1822 Bank Street

URBAN DESIGN BRIEF - R6

February 25, 2026

RESPONSE TO PRIOR URBAN DESIGN COMMENTS

VIEW FROM ABOVE NORTHWEST SHOWING 45 DEGREE ANGULAR PLANE

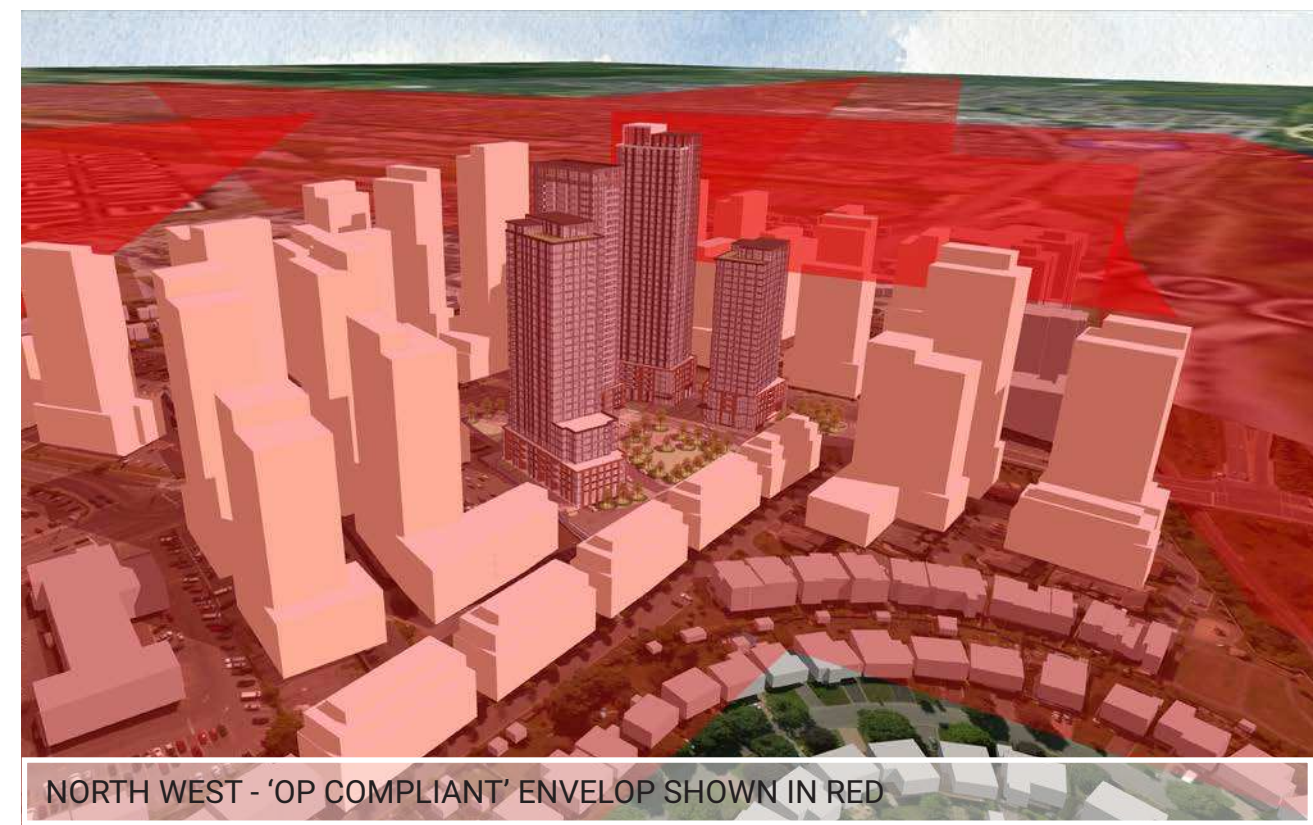
41. *Ensure effective built form transition, guided by the application of angular planes.*

17. Towers 1 and 4 protrude significantly above the 45-degree angular planes as shown on page 20 of the submitted Design Package.

ii. Tower 4 – The height should be reduced. It is interesting to note that if Tower 4 is a 16-storey building, permitted by the Secondary Plan, it will not protrude above the angular plane.

18. In addition to applying the angular planes, the podium is often used as a mediator between a tall building and the low-rise context. This is shown on Diagrams 1-3, 1-4, 1-6, 2-6, and 2-7 of the Urban Design Guidelines for High-Rise Building. In this regard, the 8-storey portion of Tower 4 is overwhelming. The podium of Tower 4 should generally remain as a low-rise.

28. Slide 20 of the Design Package demonstrates the buildings projecting above the angular plane. While the angular plane is not meant to be a rigid determination of heights, it does inform the general appropriateness of building heights. In this case, it seems to me that Building 4 should be reduced by several storeys. In addition to improving the building height transition, this would add more variation to the building heights.

30. In the Official Plan, Section 4.6.6, policies 1) and 3) speak to the built form transition between high-rise and low-rise to be guided by an angular plane in accordance with Council-approved Plans and Guidelines, which is further detailed in the Urban Design Guidelines for High-Rise Buildings, Section 1. In the applicant's Design Package, slide 20, the 45-degree angular plane is applied and shows that the proposed building heights clearly and significantly exceed the angular plane. The proposed building heights for buildings 2 & 3 along Bank St are acceptable, however, buildings 1 & 4 should be reduced in height in order to provide an appropriate building height transition.

Applicant: Please refer to the angular plane diagrams included in the UDRP submission set. We feel that the proximity to the transit station and future development potential under the OP justifies some elements of the development breaking the 45 degree angular planes. The trade-off the proposed development offers is providing the majority of the western edge as greenspace. This minimizes the number of the existing townhomes impacted by overlook / shadowing.

Applicant: We acknowledge that towers 1 and 4 protude through the angular plane. However we feel that this massing response is reason given the significant adjacent open space gained by locating the park at the west side of the property closest to adjacent low-rise. The park location serves to balance the impacts of the taller building forms. Additional, building 1 is the closest of the buildings to the new transit station, and therefore an appropriate location for a taller / higher density form. To help mitigate the impacts on, and improve transition from, the lowrise neighbour to the west, we have reduced Building 4 by 2 storeys to 32 storeys and increased Building 3 to 36 storeys.

Applicant: See comment 17 above.

Applicant: See comment 17 above.
